Exterior Rear View Mirror Vibration

Service
Category Vehicle Exterior

YEAR(S)	MODEL(S)	ADDITIONAL INFORMATION
2008 – 2011	Land Cruiser

1 Lower Base Cover

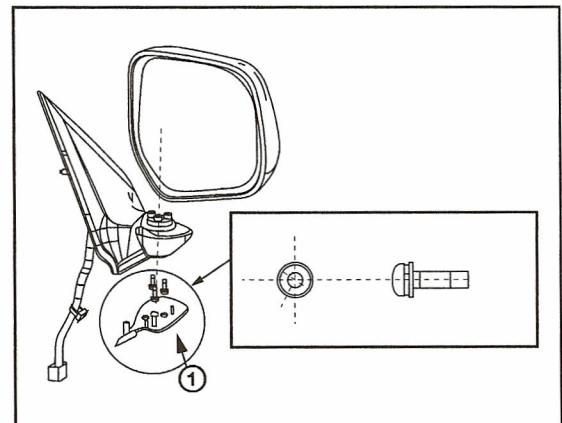
Some Land Cruiser vehicles may exhibit a condition where the exterior rear view mirror vibrates while driving. A bolt set has been developed to change this condition.

1. Using a plastic pry tool, remove the lower base cover from the mirror housing assembly.
2. Remove and replace the 3 torx bolts with the new bolt set. **Figure 1.**

Torque: 3.7 N*m (37.7 kgf*cm, 33 in*lbf)

3. Replace lower base cover with new one provided in bolt set.
4. Road test vehicle to confirm proper operation of mirror assembly.
